Inspection Report of Sri. D.R. Kumaraswamy, Chief Environmental Officer-3, Bangalore-79.

Dated: 27-06-2016

Name of the industry	M/s. Katra Phytochem (India) Pvt. Ltd., No. 7, A-1, Attibele Indus trial Area, Anekal Taluk, Bangalore-562107.
Date of inspection	25-06-2016
Regional Officers present (Sarjapura)	 Sri Rajashekar, RO, Sarjapura, KSPCB, Bangalore. Sri. Siddeshwara Babu, DEO, Sarjapura, KSPCB.
Factory authorities present	 Sri. Bhasker-Quality and Safety Manager (9886853266). Sri. Sathish- Plant In-charge (9538816504).
Consent status	Valid upto 30-06-2016 consent under both Acts.
Category	Large- Red, Capital Investment:- 18.43 Corres
Products manufactures as per consent in Kgs/month	 Lutein Esters Concentrate - 750. Lutein Concentrate - 1150. Zeaxanthin Concentrate - 100. Fomulation of Lutein Esters Granules - 2500. Lutein water dispersible - 1100. Lutein Water Formulation - 2400. Zeasanthin Granules - 140.

CORRODED PLAT FORM OF ETP

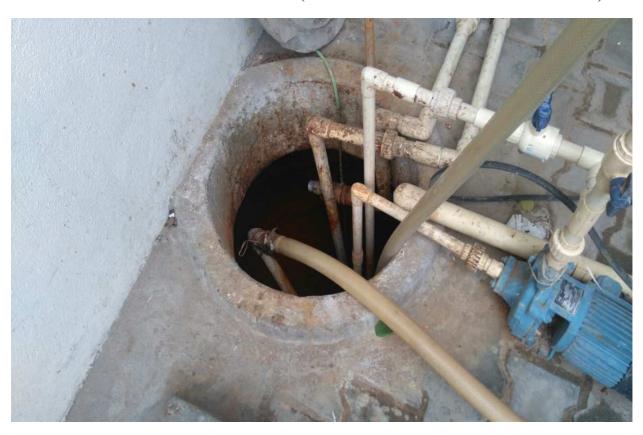
7.	A7	They are not separately constructed storm water drains.
8.	A8	The effluent treatment plant was not in operation at the time of the inspection. The factory authority informed that they have stopped the activity from 07-06-2016 due to maintenance. After verification it came to know that they are not scientifically operating the ETP. They have started ETP during April-2016 but there was no MLSS in the aeration tank which indicates they don't know how to operate the ETP.
